ROOF PLAN (MONO SLOPE)
SCALE 3/8" = 1'-0"

SHEET
A4

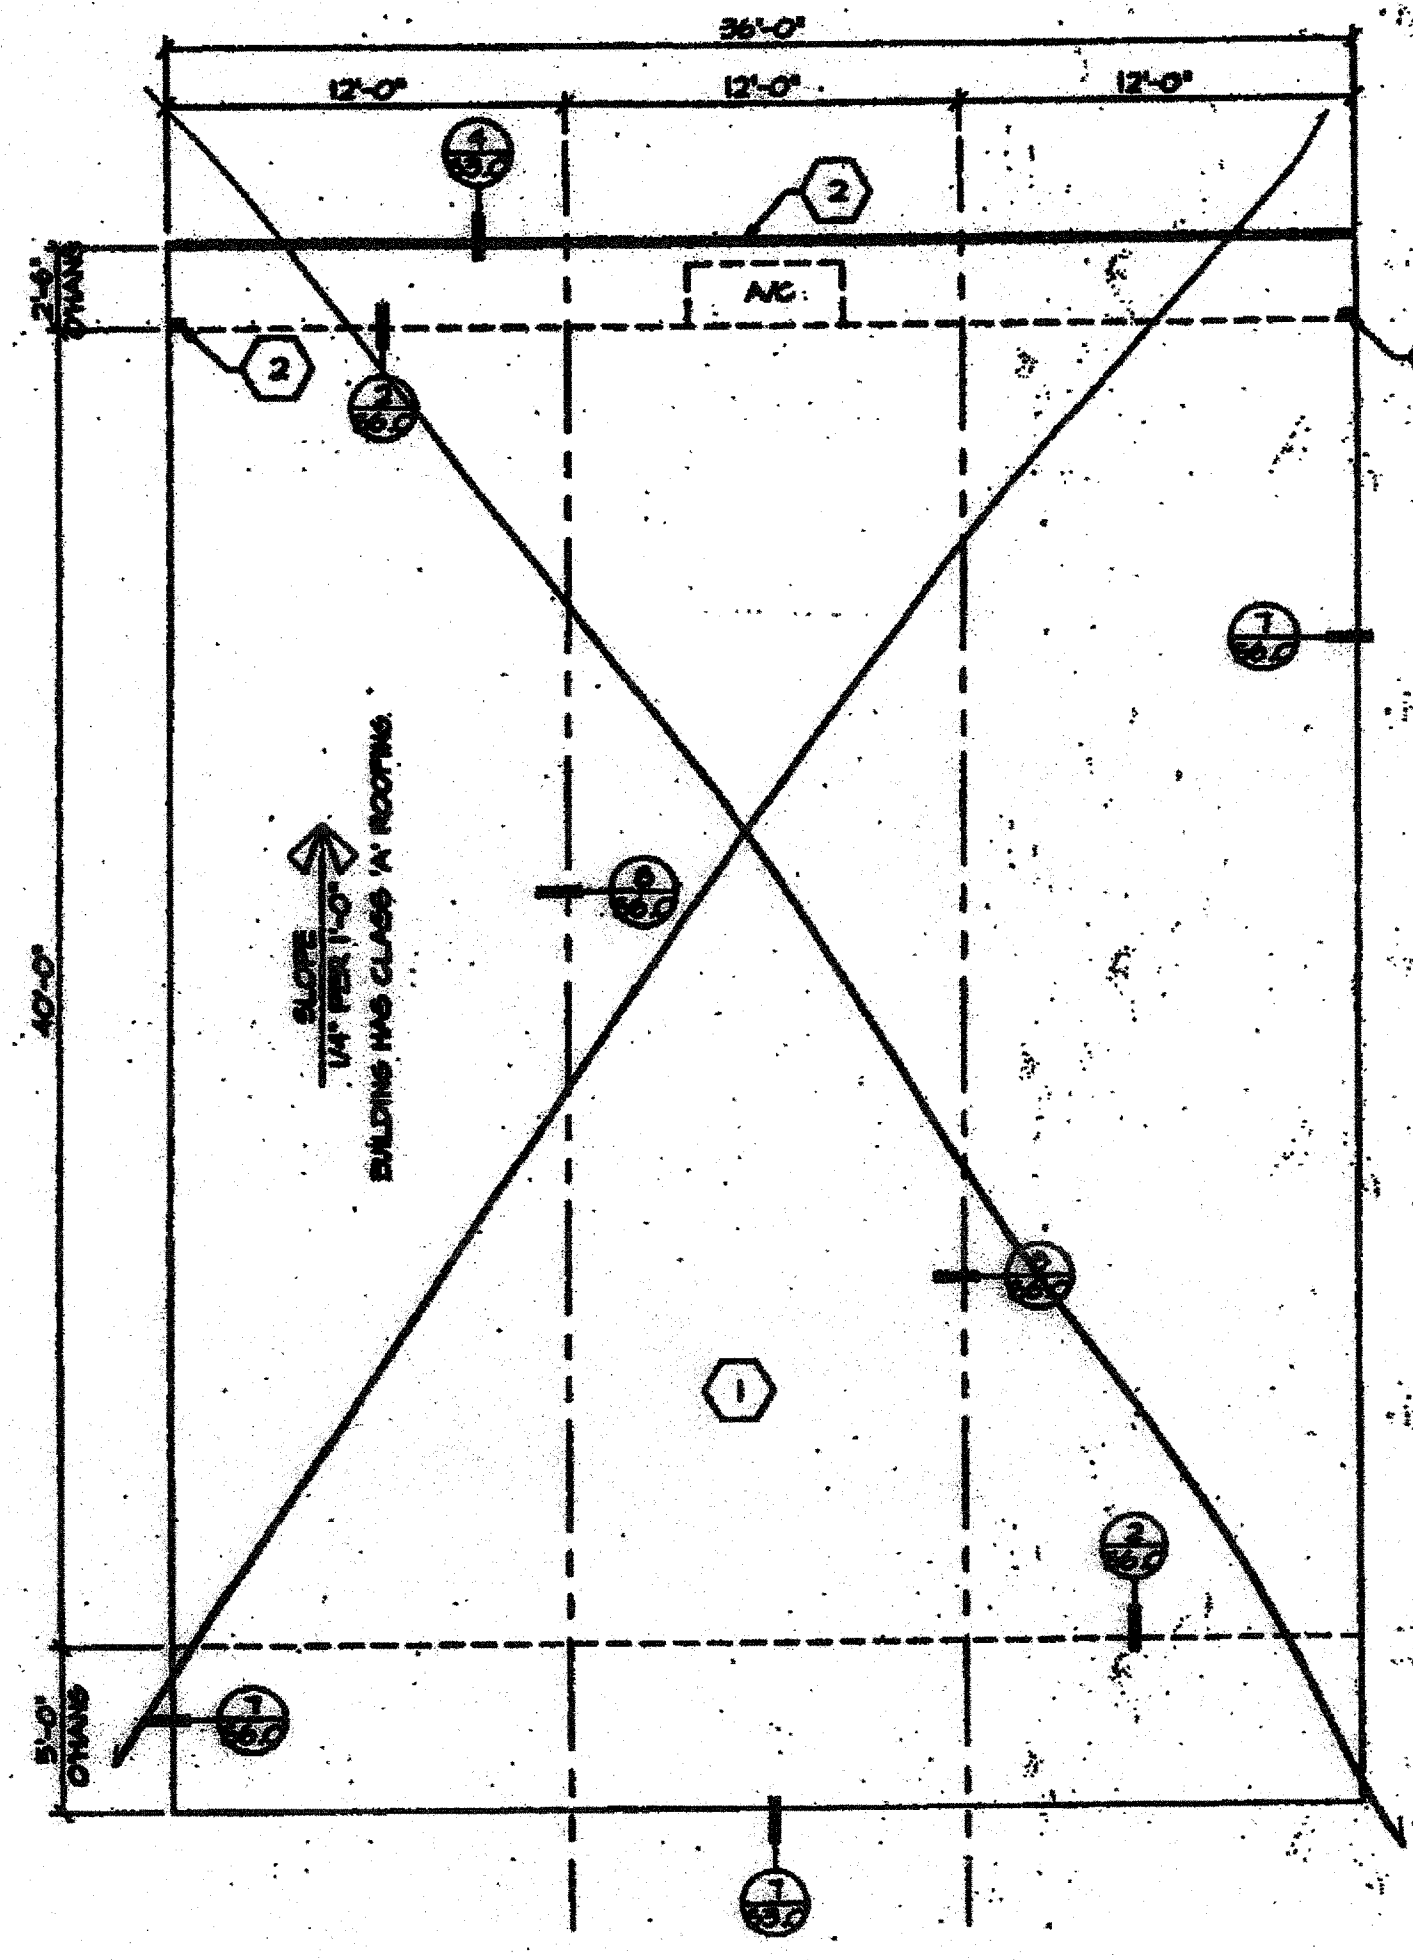
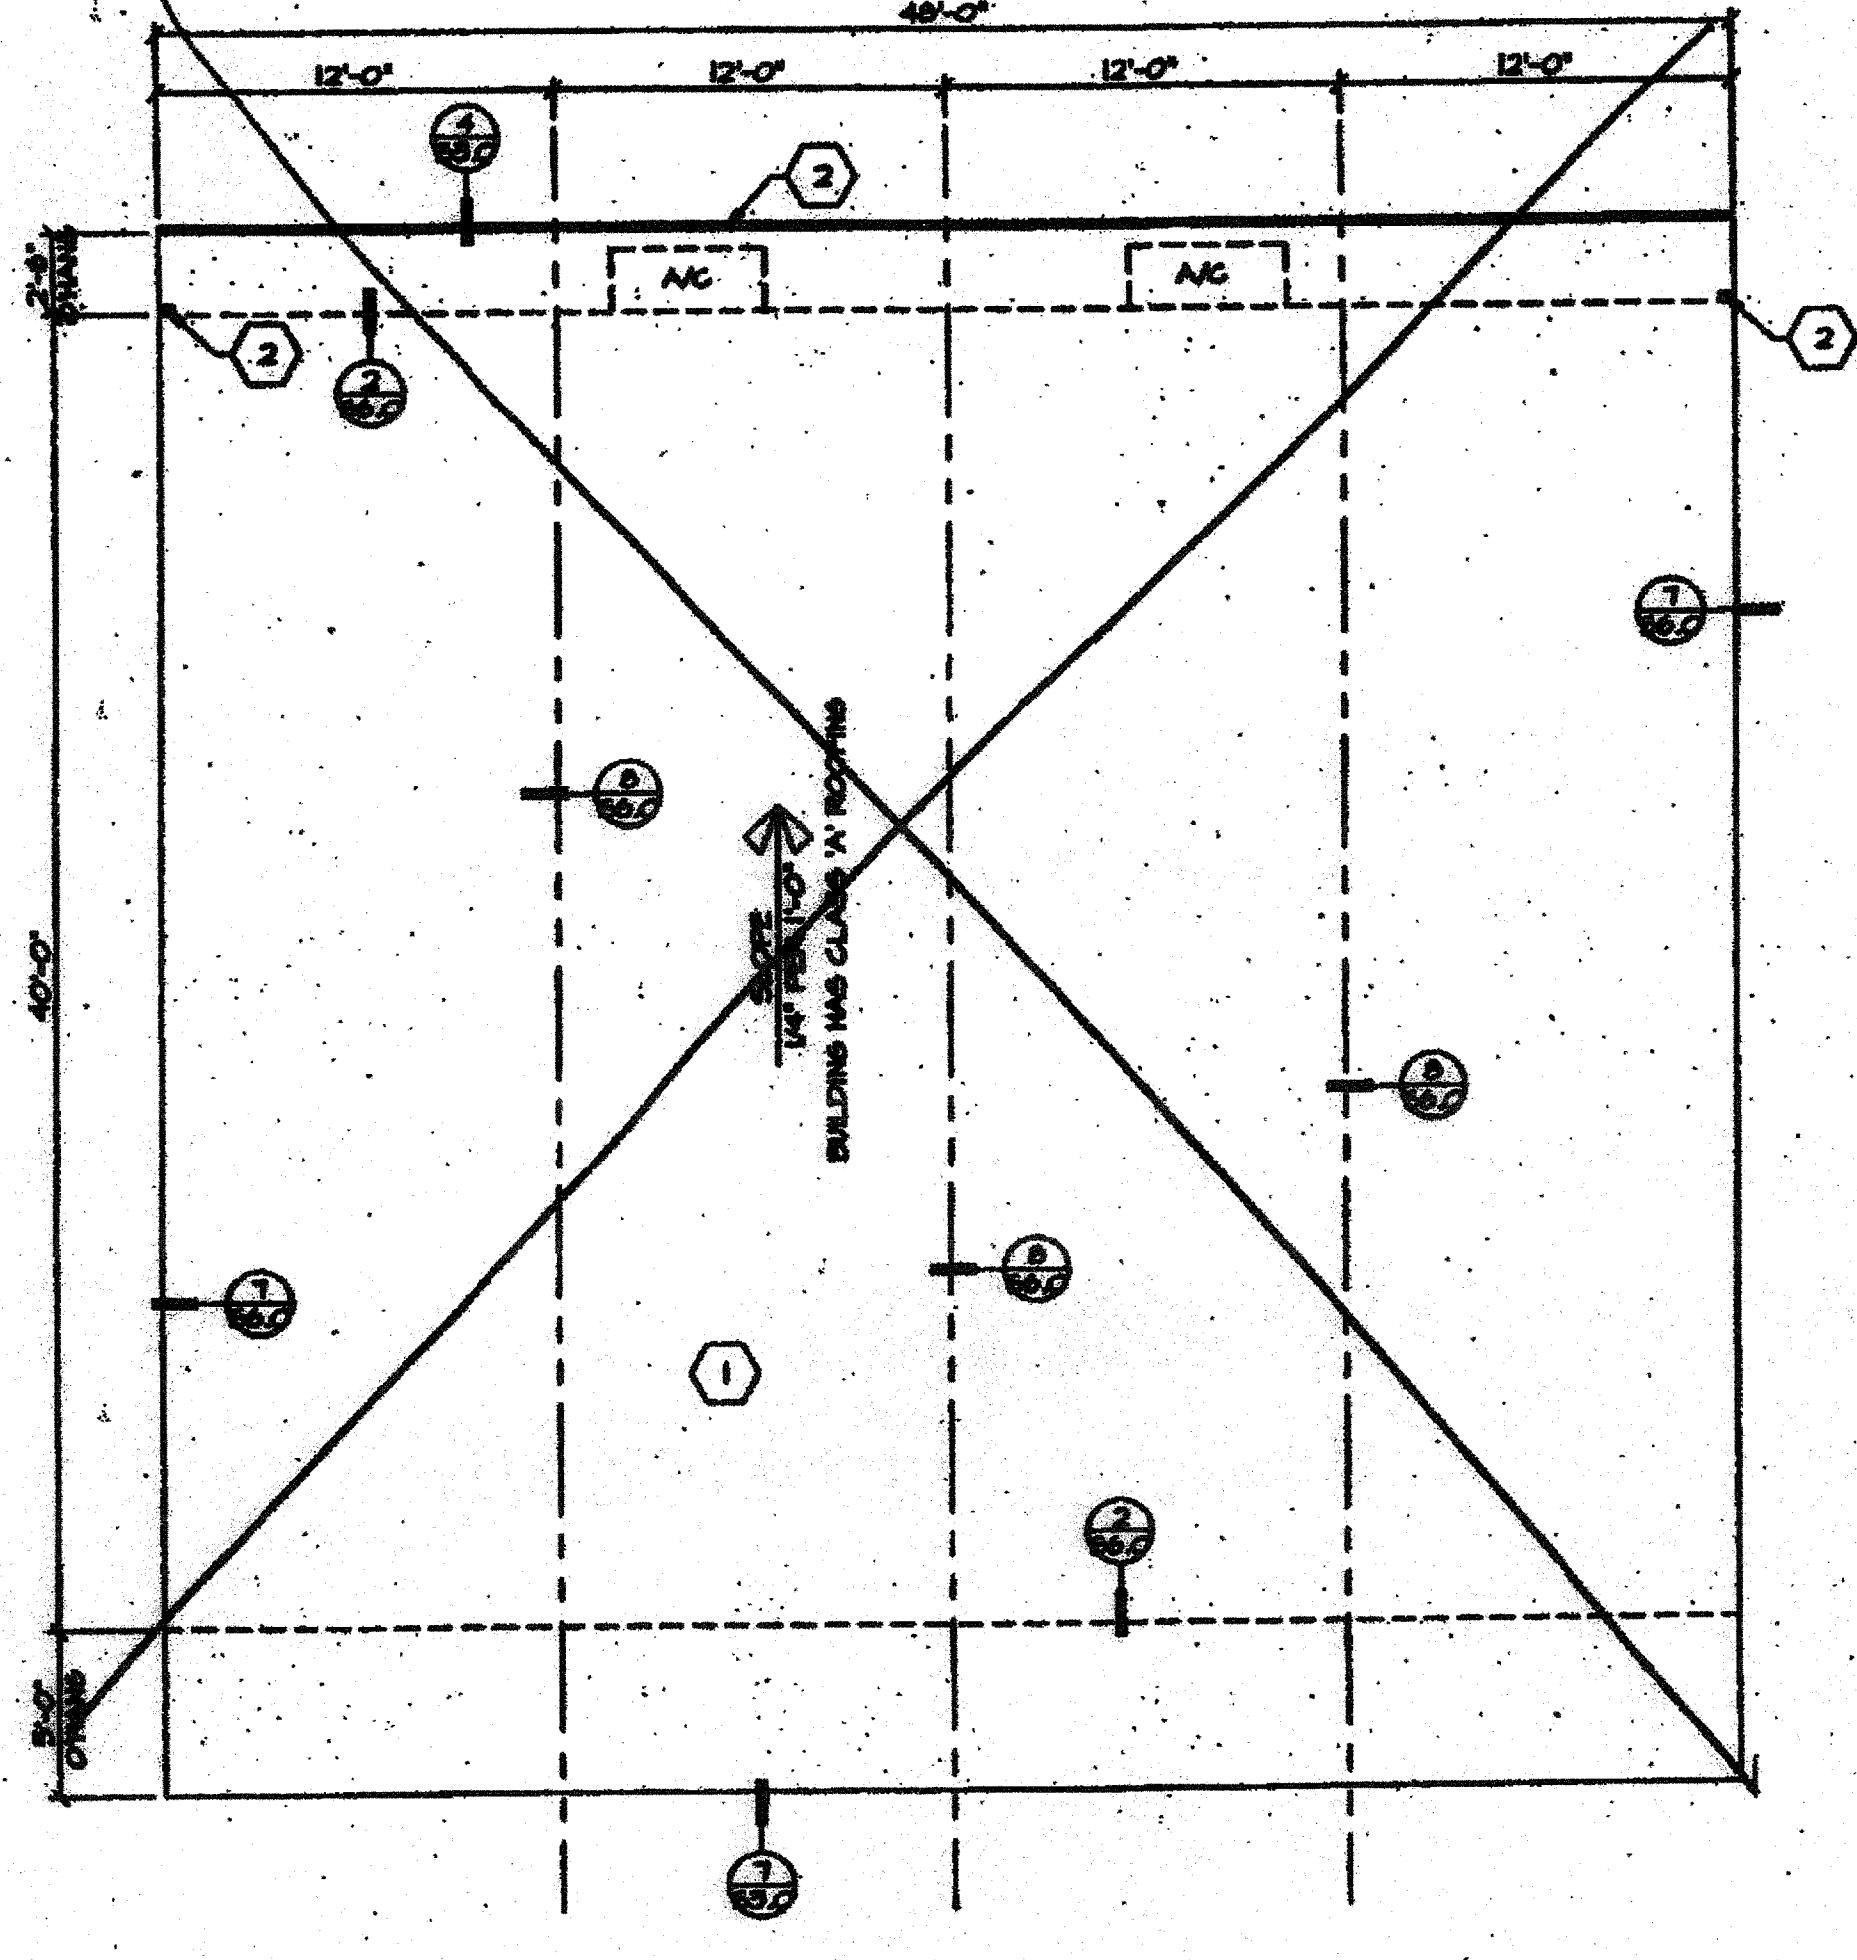
~~36x40~~

~~48x40~~
